TO: Mayor Eric Dial, Town of Tyrone  
ATTN TO: Phillip Trocquet, Town Planner, Town of Tyrone  
FROM: Mike Alexander, Director, ARC Center for Livable Communities  
RE: Development of Regional Impact (DRI) Review

**Name of Proposal:** Highway 74 Business Tech Park DRI 3628

**Description:** A DRI review of a proposal to construct 733,882 SF of warehouse distribution facility space in five buildings on a 61 acre site off of SR 74/Joel Cowan Parkway at Jenkins Road in the Town of Tyrone in Fayette County.

## Development of Regional Impact Assessment of Consistency with the Regional Transportation Plan

DRI

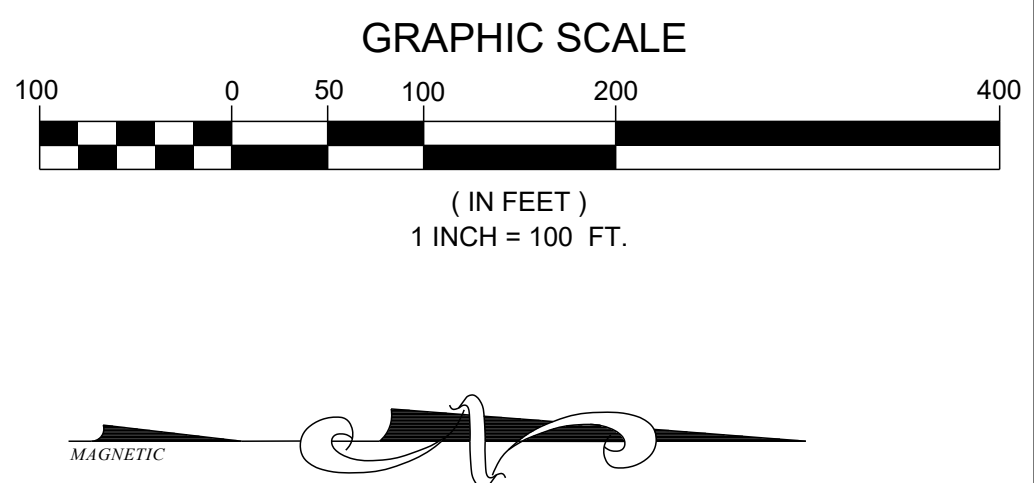
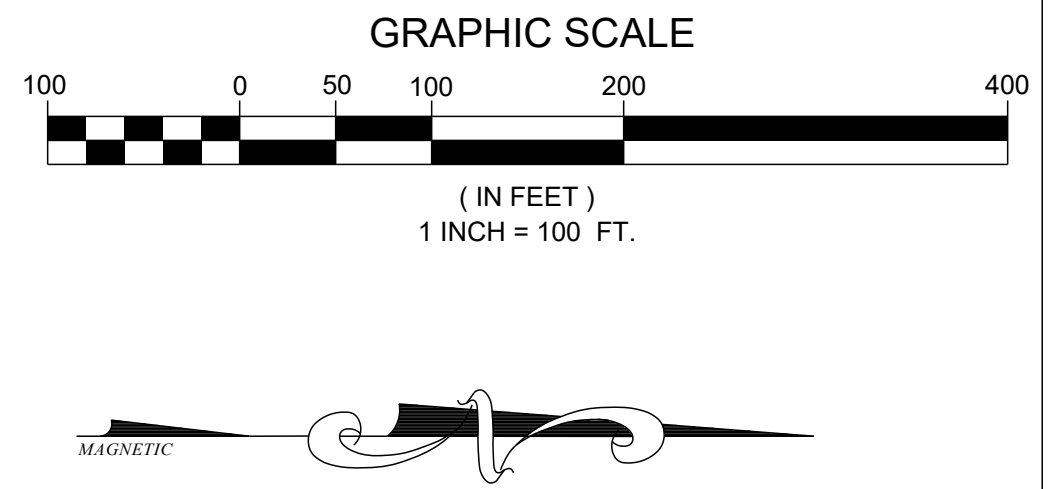
*It appears that the headwaters of a mapped stream are located in the area of the southern stormwater pond; the actual location of the stream will need to be identified to definitively determine if any stream buffer requirements apply on this site.*

*No sidewalks are shown on the site plan, but the TIS states that sidewalks will be provided between buildings. A multi-use trail is proposed on the east side of the project that will connect to Peachtree City; careful alignment of the trail with connecting segments to the north and south will be key to making it viable.*

No sidewalks are shown on the site plan. Sidewalks between buildings connecting to a future external sidewalk system or transit opportunities are considered a minimum component of a multi-modal transportation strategy. The proposed multi-use trail on the east side of the project is a positive feature but it will need to be integrated with connecting segments to the north and south to ensure its viability. Care should be taken to ensure that the constructed development provides an interconnected, functional, clearly marked and comfortable pedestrian experience on all driveways, paths, entrances, and parking areas. To the maximum extent possible, new driveways and intersection corners where pedestrians will

The proposed project site plan shows no blue line streams on the property. The USGS coverage for the project area shows an unnamed tributary to Whitewater Creek ending in a pond at or near the eastern boundary of the property in the approximate area of the larger stormwater pond shown on the site plan. The precise location of the stream will need to be identified to definitively determine if any stream buffer requirements apply on this site. In addition to the Part 5 criteria listed above, the City of Tyrone stream buffer ordinance requires a 50-foot undisturbed buffer and a 75-foot impervious surface setback. Any unmapped streams on the property may also be subject to the City's Stream Buffer Ordinance. Any unmapped streams as well as any other waters of the state on this property are also subject to the State 25-foot Sediment and Erosion Control Buffer.

If trucks enter to the site using Jenkins Road via Driveway C, then the truck will have to pass through the employee parking to reach the service courts.

The proposed project site plan shows no blue line streams on the property. The USGS coverage for the project area shows an unnamed tributary to Whitewater Creek ending in a pond at or near the eastern boundary of the property in the approximate area of the larger stormwater pond shown on the site plan. The precise location of the stream will need to be identified to definitively determine if any stream buffer requirements apply on this site. In addition to the Part 5 criteria listed above, the City of Tyrone stream buffer ordinance requires a 50-foot undisturbed buffer and a 75-foot impervious surface setback.
